3708 BRADLEY LANE, KEVY CHASE  
[HPC CASE # 35/13-13#]

**SUBJECT:** WINDOW CHANGE (ALL-WOOD TO WOOD-CLAD), FAÇADE, 3708 BRADLEY LANE, CONTRIBUTING RESOURCE, CHEVY CHASE VILLAGE

**SUBJECT:** Revision to approved HAWP for demolition of non-historic addition and construction of rear addition and other alterations additions at 3708 Bradley Lane, Chevy Chase, a Contributing Resource within the Chevy Chase Village Historic District

**MONTGOMERY COUNTY HISTORIC PRESERVATION COMMISSION**  
**STAFF REPORT**

FRONT, NO CHANGE

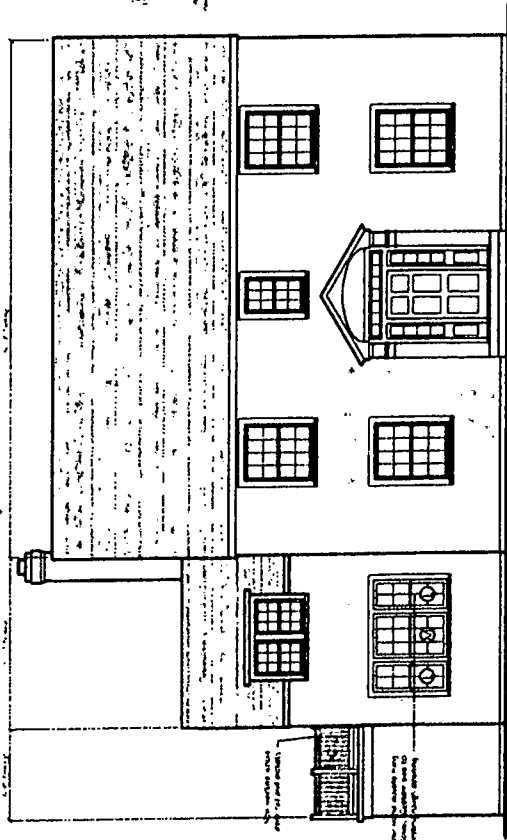
**REVISED PROPOSAL:** The applicant is requesting HPC approval to install, wooden interior, aluminum-clad exterior, simulated-divided light, windows (double-hung and casement type), and doors in lieu of the approved all wooden windows and doors in the addition section of the house. See attached plan for window and door locations.

The proposed work is confined to the rear and side elevations of the HPC approved addition. The window and door light configurations and types will remain unchanged from what the HPC found as being compatible in character with the resource. The proposed work is an exterior material change to the windows and doors only.

Proposed Exterior Elevations

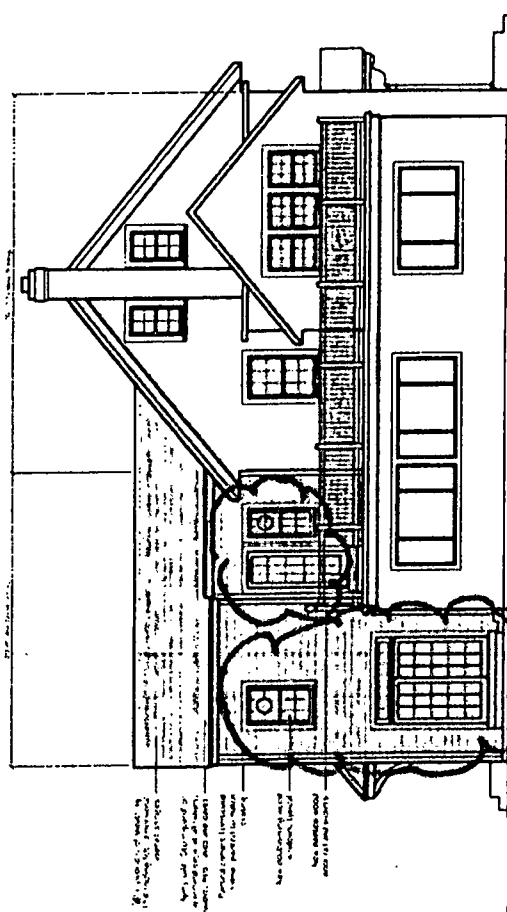
2 DOORS, 2 WINDOWS

Proposed Exterior Elevations

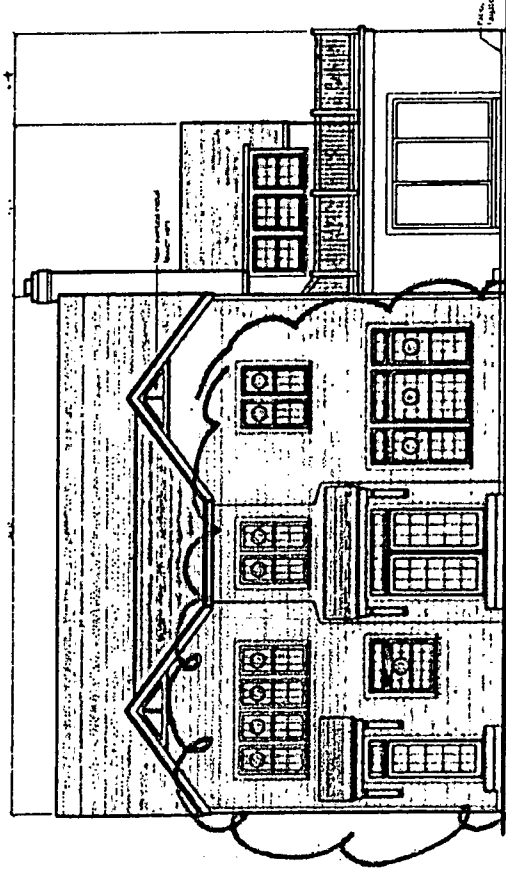
2 DOORS, 2 WINDOWS

Proposed Exterior Elevations

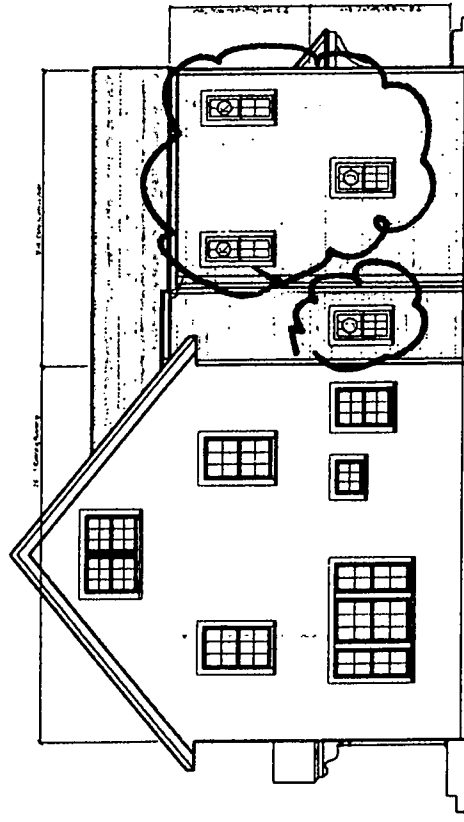
4 WINDOWS
